**7.1 NOTICE OF PREPARATION (NOP), WRITTEN COMMENTS  
AND SUMMARY OF SCOPING MEETING**

SUBJECT: **NOTICE OF PREPARATION and NOTICE OF SCOPING MEETING FOR THE CACHE  
CREEK RESOURCES MANAGEMENT PLAN PROGRAM-LEVEL (CCRMP)  
ENVIRONMENTAL IMPACT REPORT (EIR)**

Comments on Draft CCRMP

Figure 1. -- Map of Cache Creek area showing possible locations of native vegetation and floodplain.

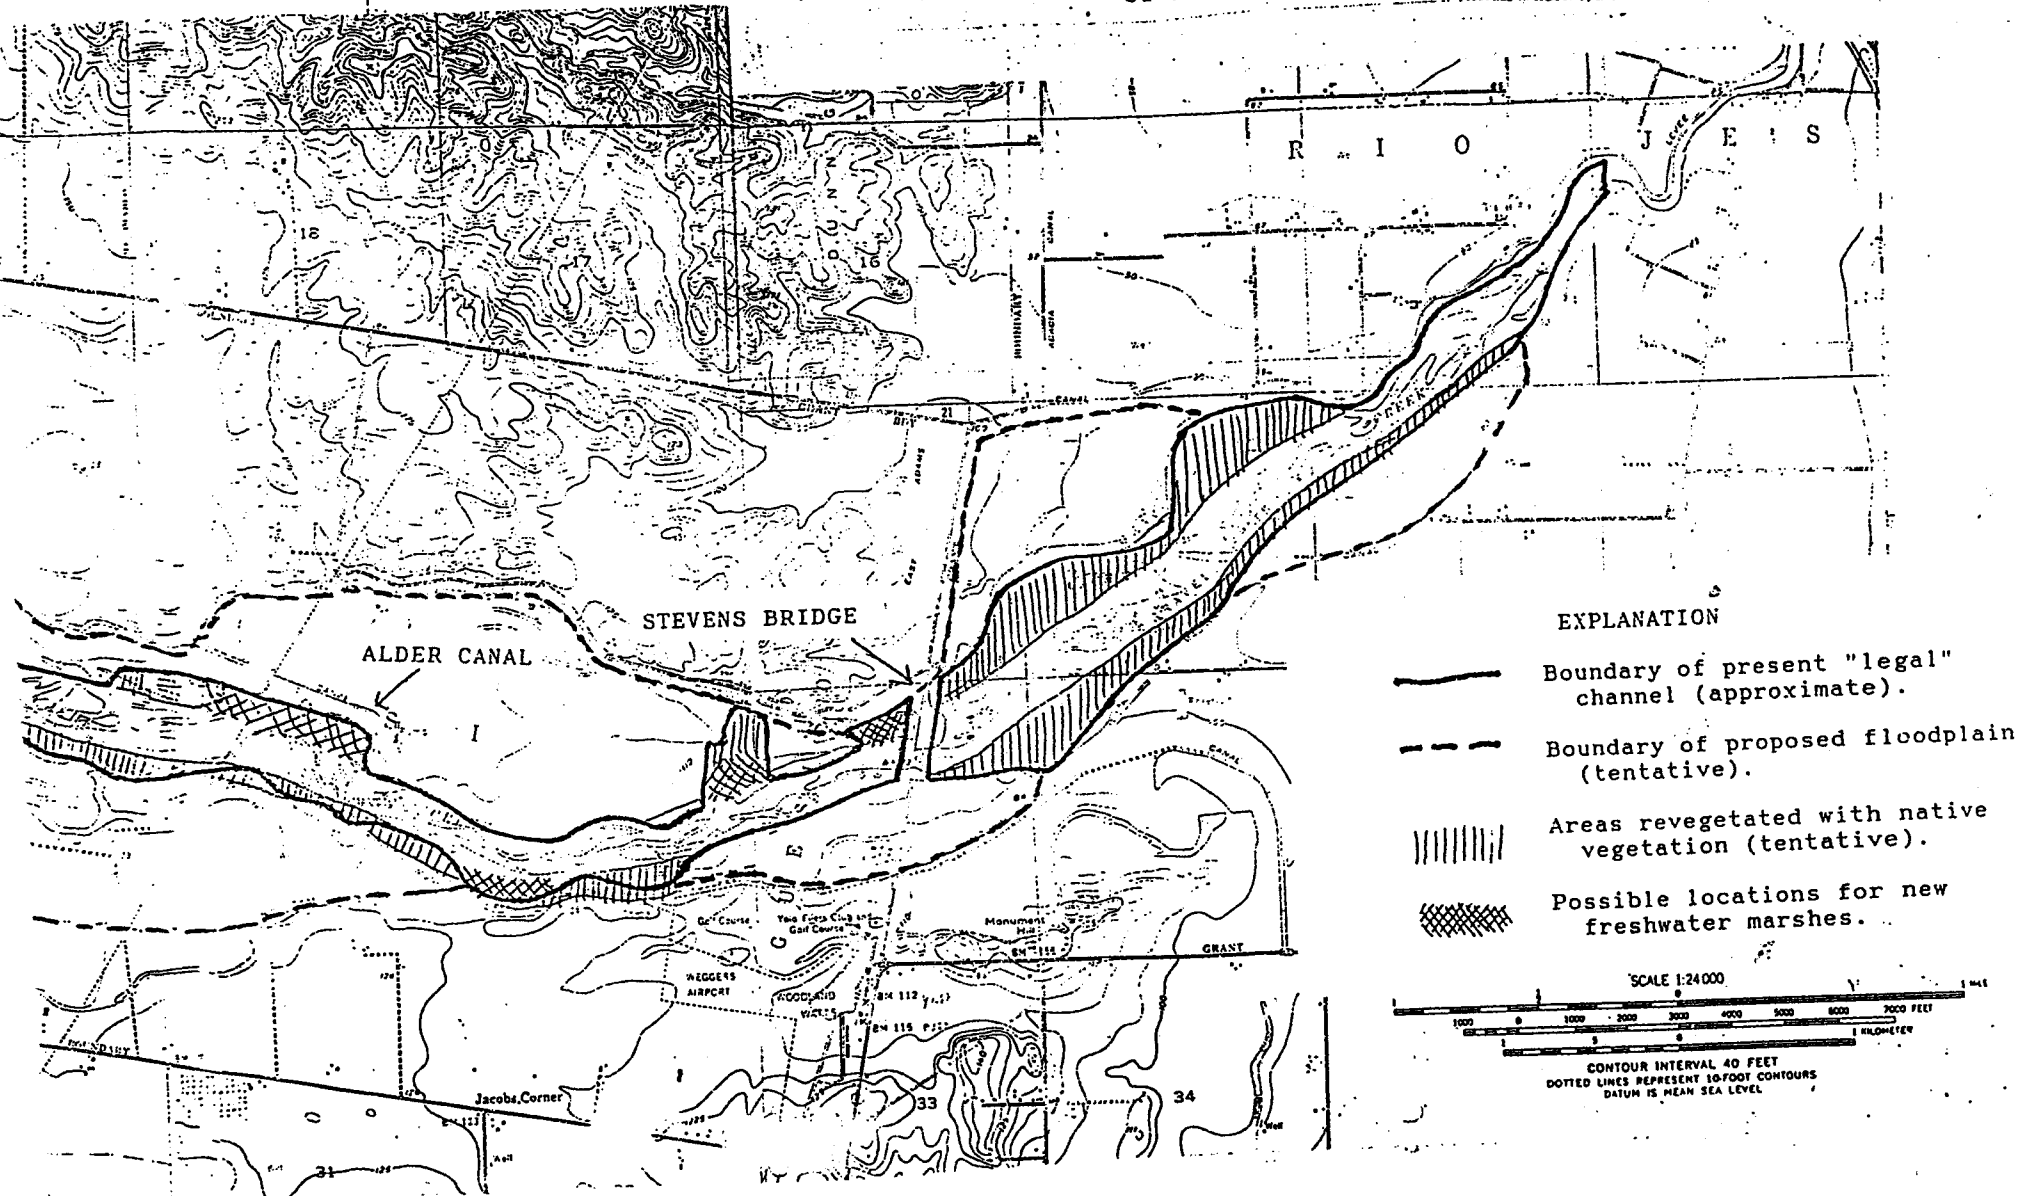
1. Mining above seasonal high water table only. [Water table measured on site by shallow piezometers.]
2. Mining only between creek and nearest major east-west road, canal, or developed area (see figure 1 for possible boundaries of floodplain).
